Architectural Review Committee

TOWN OF BROOKFIELD ARCHITECTURAL REVIEW COMMITTEE STAFF REPORT

RE: ARC Staff Report – May Agenda Items

Master Spa Warehouse – Preliminary Approval

SITE PLAN

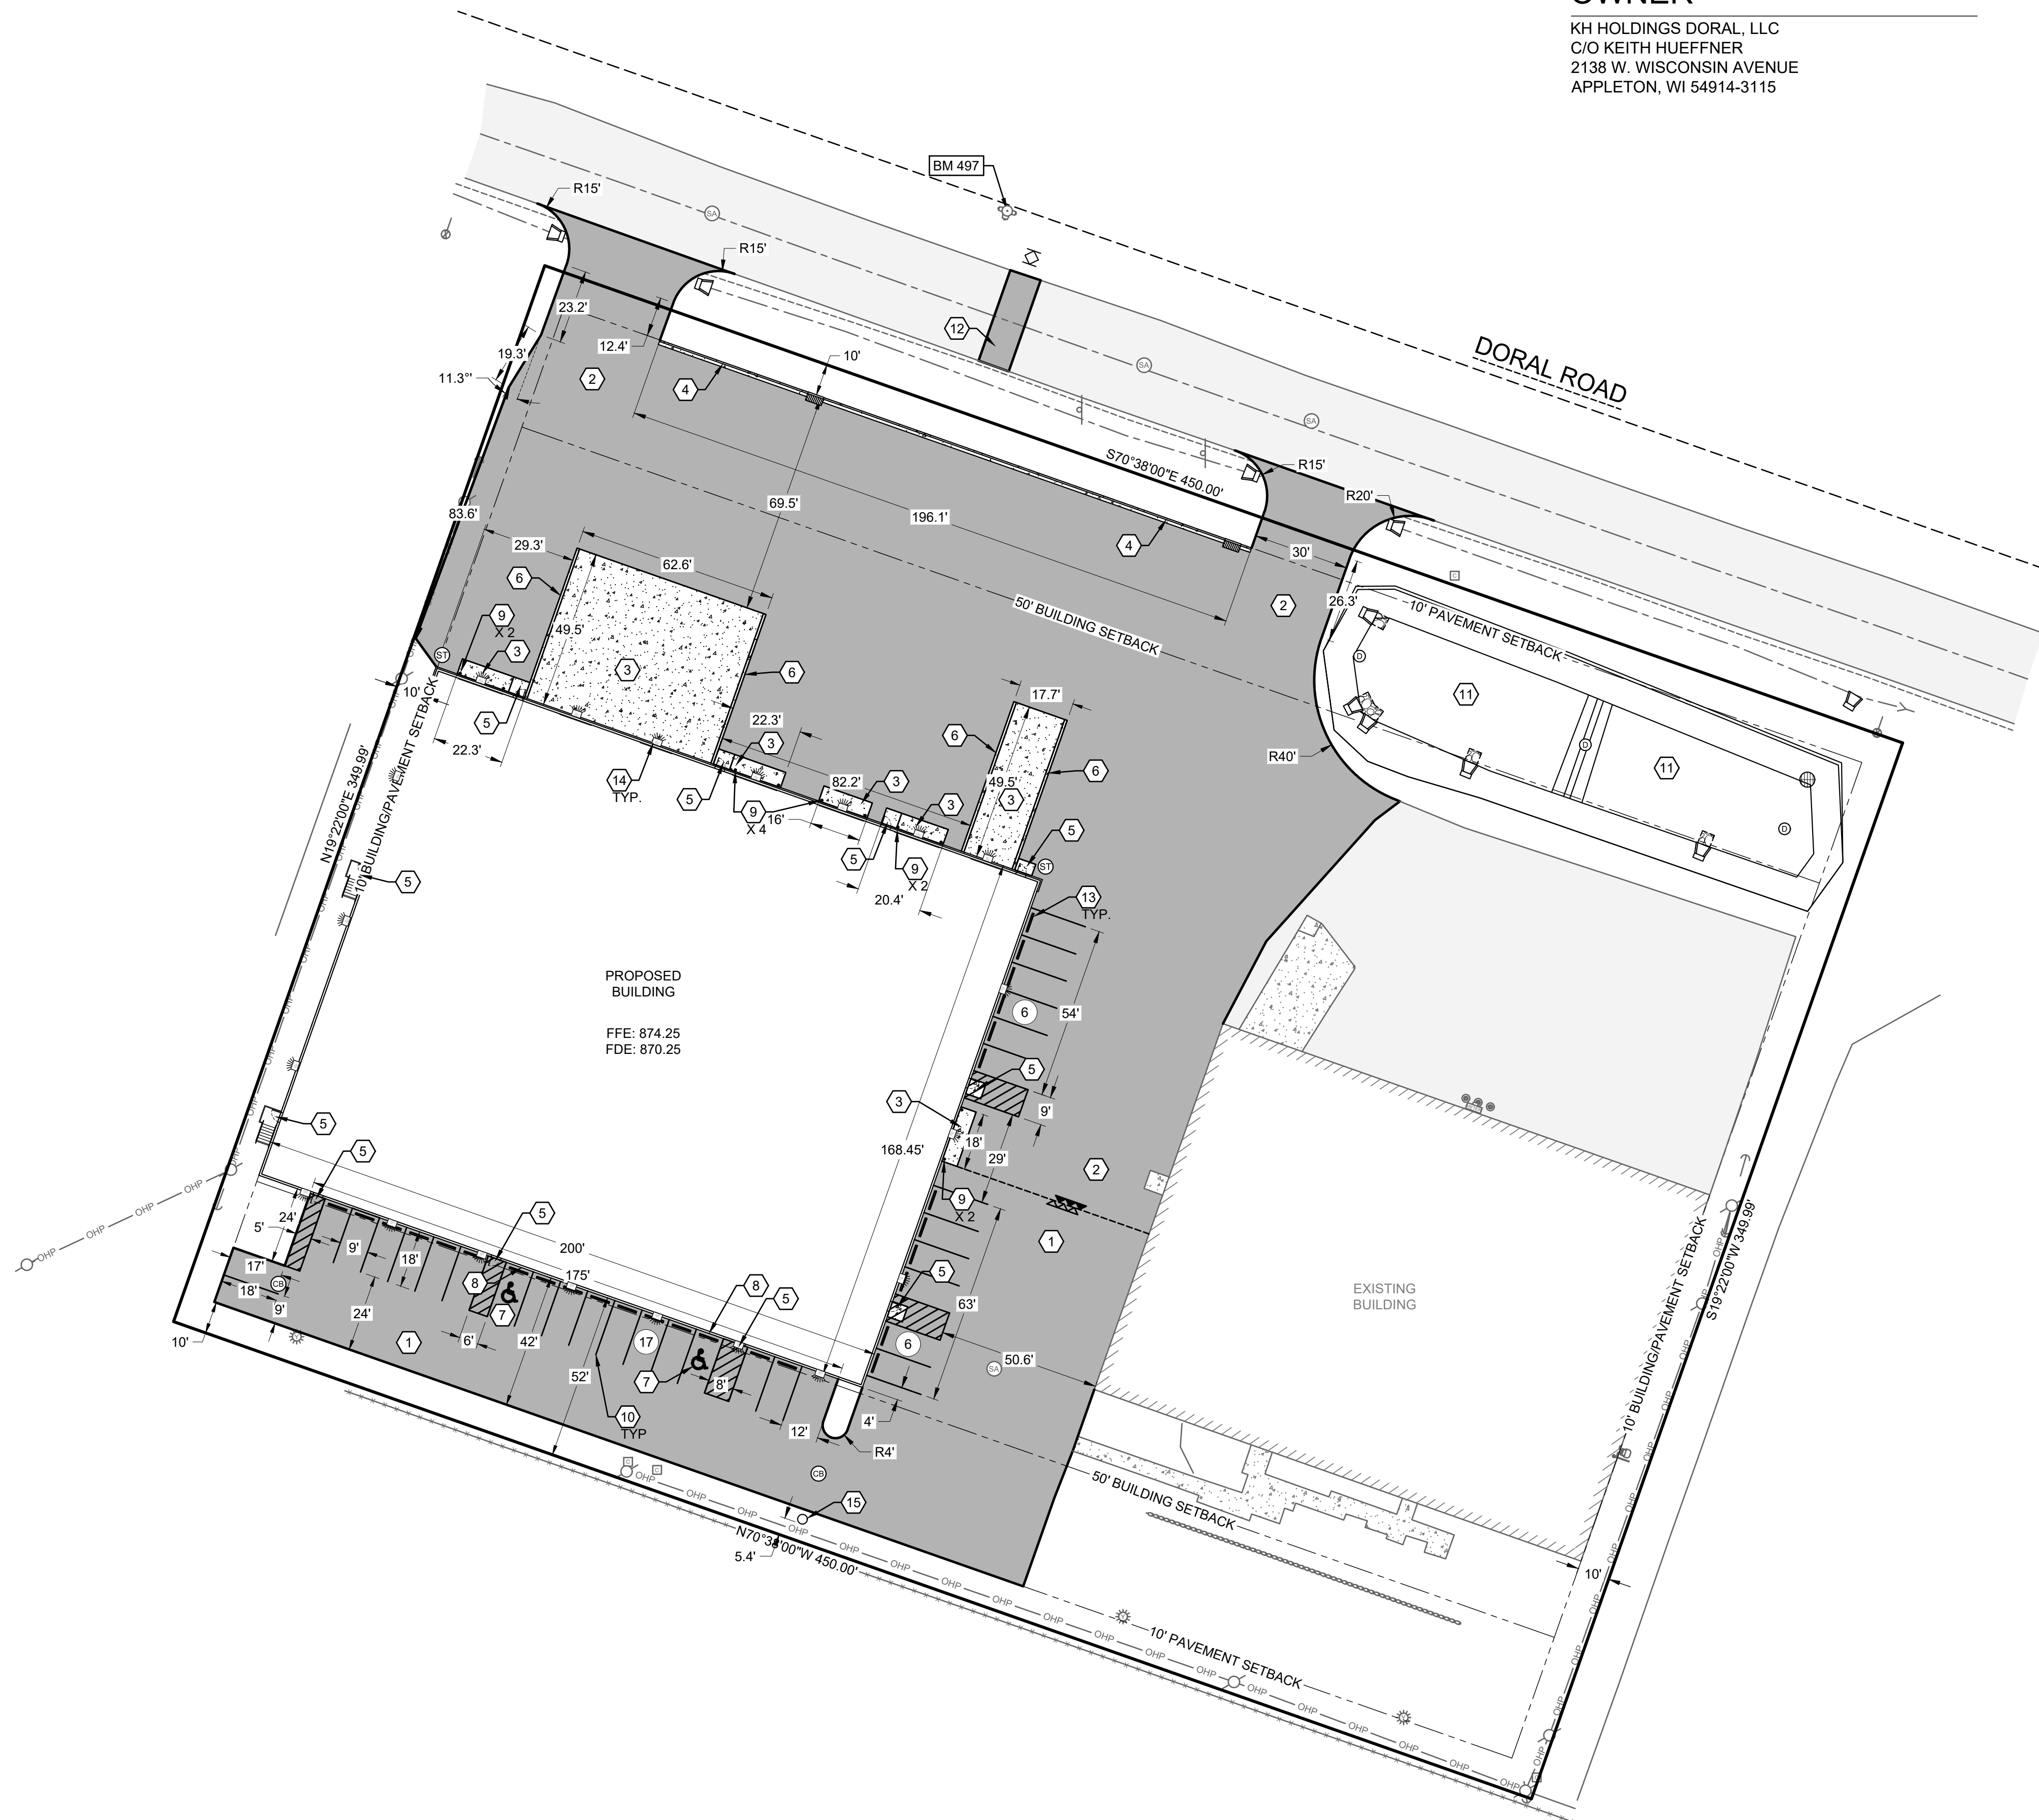
1. The distinct limits of the standard and heavy duty asphalt are not clear. It is recommended to use different hatchings or shadings for the different asphalt types.
2. Based on the architectural drawings, it appears there will be a railing on the loading dock retaining walls. It is recommended to add a detail for the railing showing the type with dimensions and installation notes and details.

3. A turning-moving exhibit should be provided to verify the largest vehicle (including any emergency vehicles) that will access the site can perform the required turning movements with the proposed layout.
4. It should be verified that the minimum dimensions for Americans with Disabilities Act (ADA)-compliant parking spaces provided for use by physically disabled persons shall be 12 by 18 feet (in accordance with Town Code 17.06(3)(c)4.).
5. It should be verified that the proposed ADA route into the building is ADA compliant.

GRADING PLAN

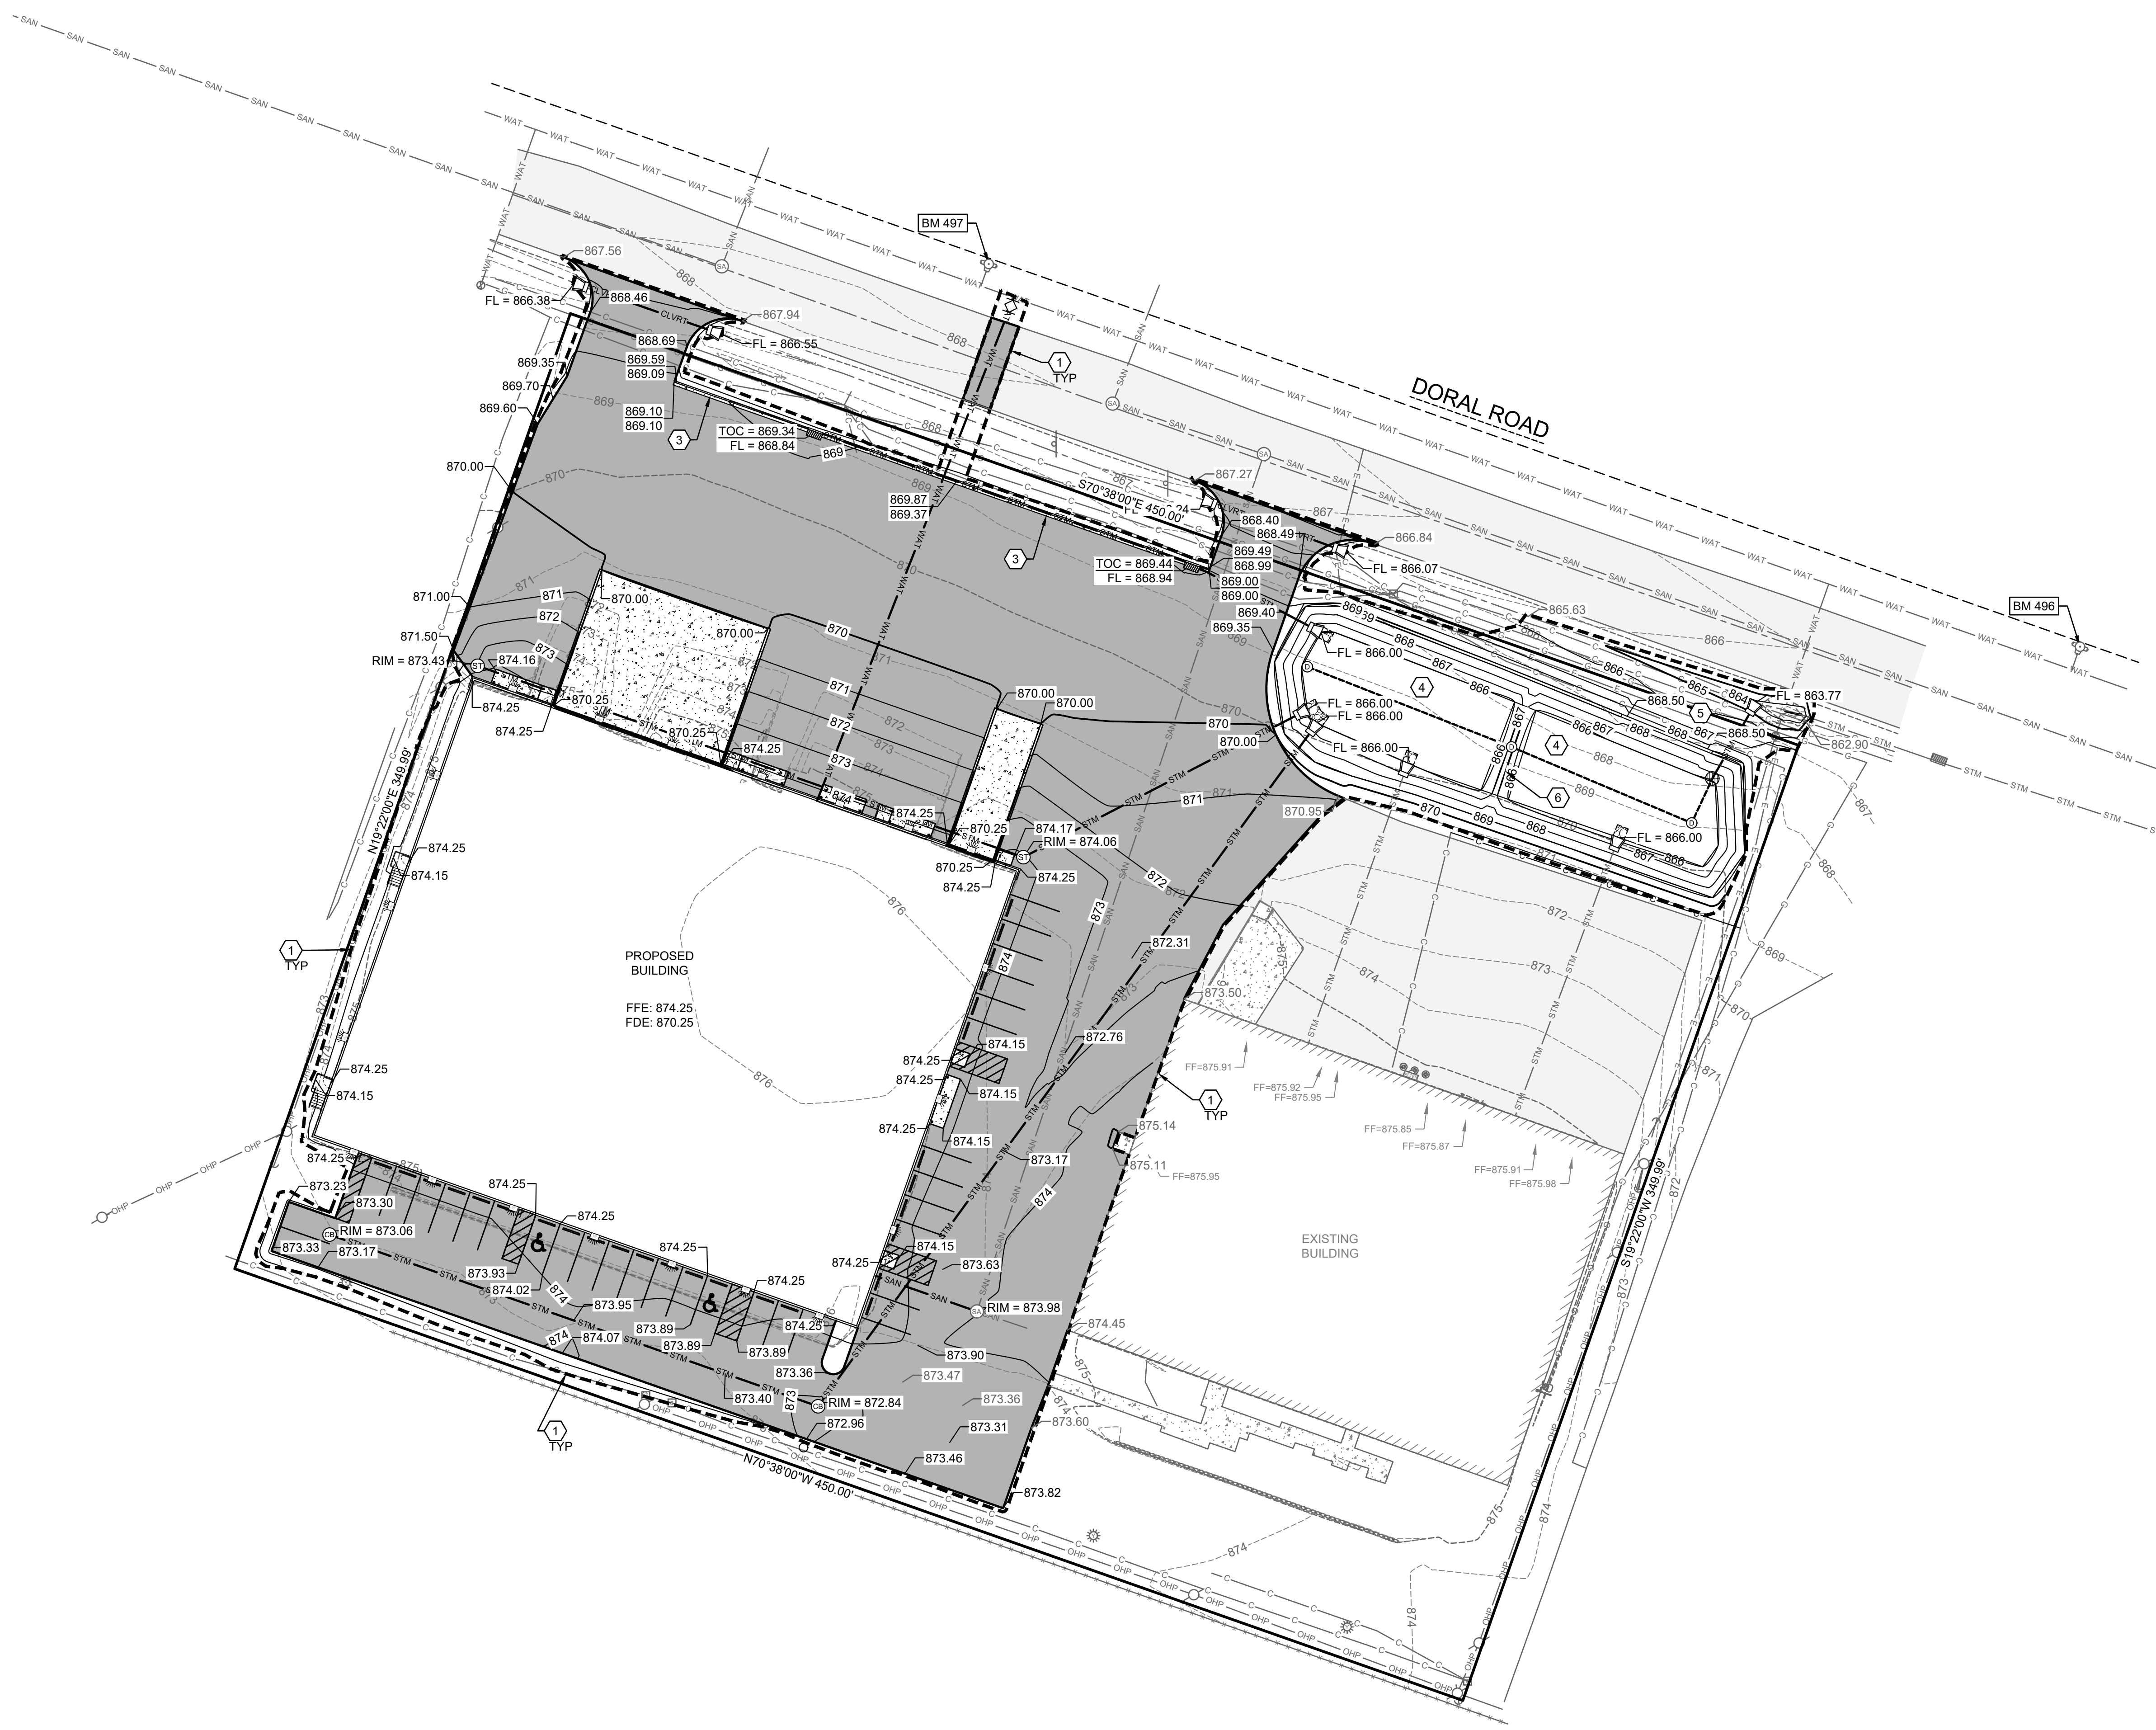
1. It appears that the width of the berm for the biofilter (elevation equal to 869.00) is only 1 foot wide. It is recommended to make this wider for ease of construction and maintenance.
2. It is recommended to denote the top and bottom of wall elevations for the loading dock retaining walls or provide a construction detail for each wall.

LANDSCAPE PLAN

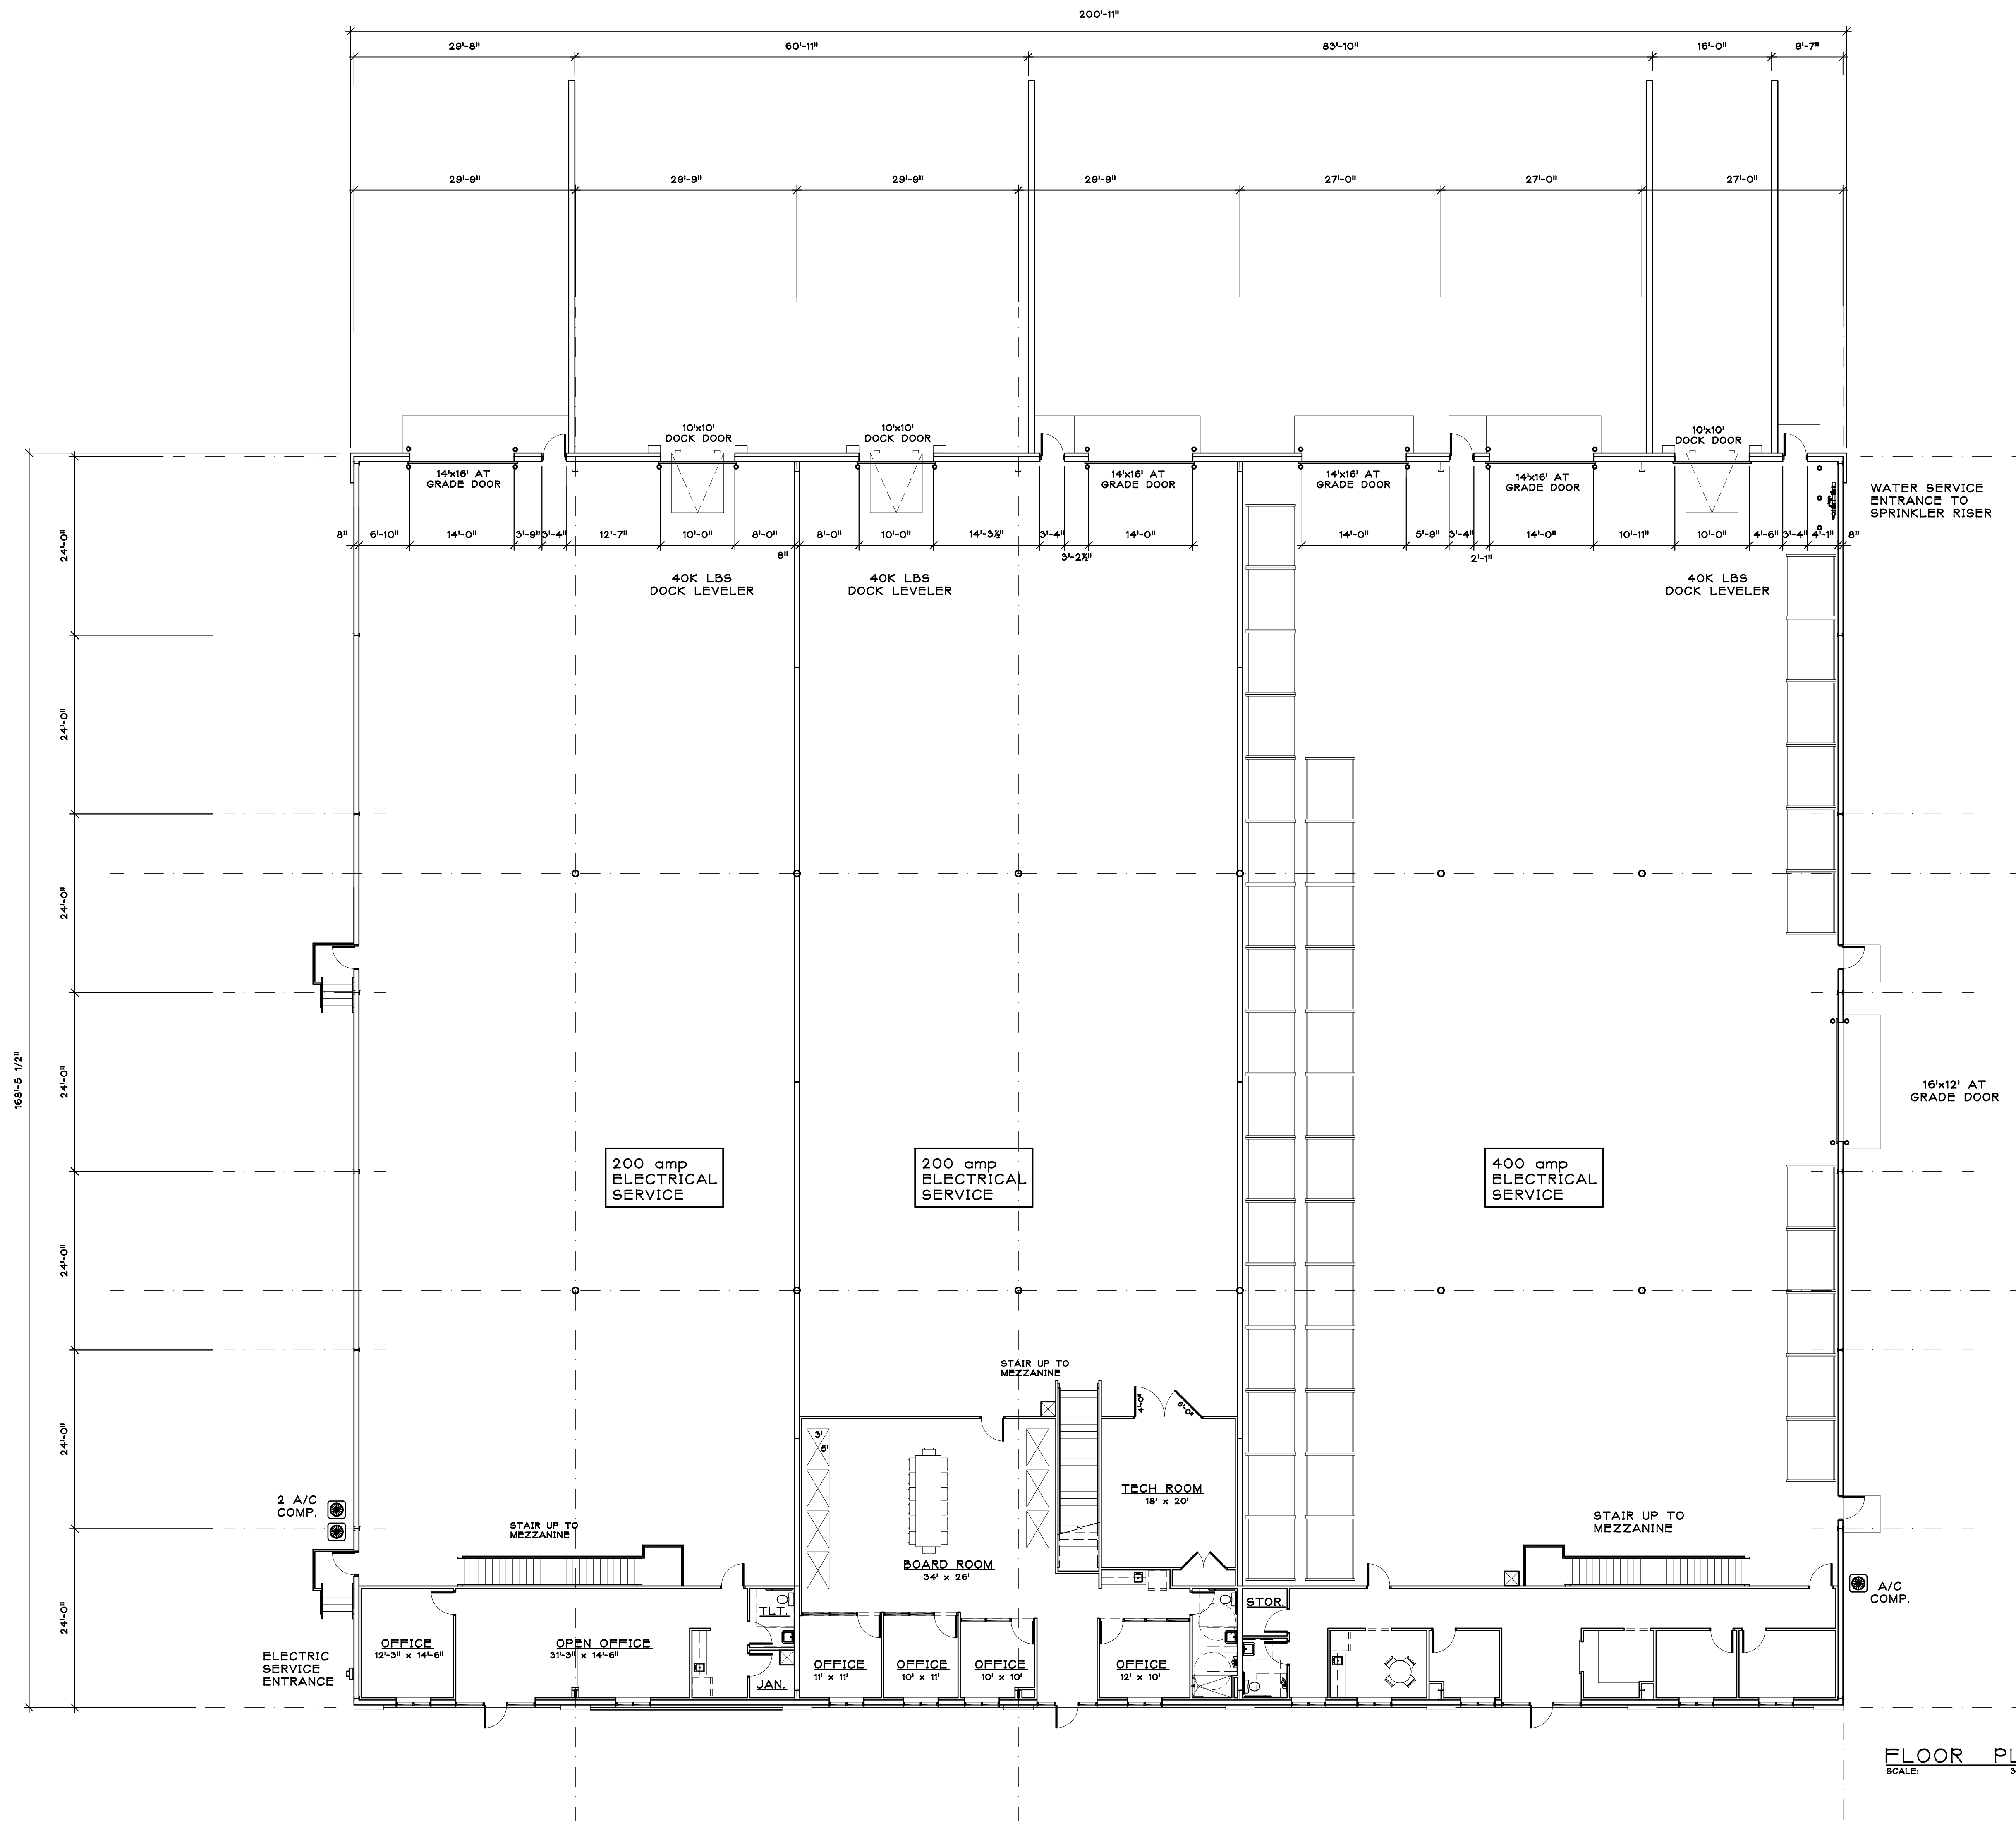
1. The landscape plan was reviewed and appears to be adequate for the site.
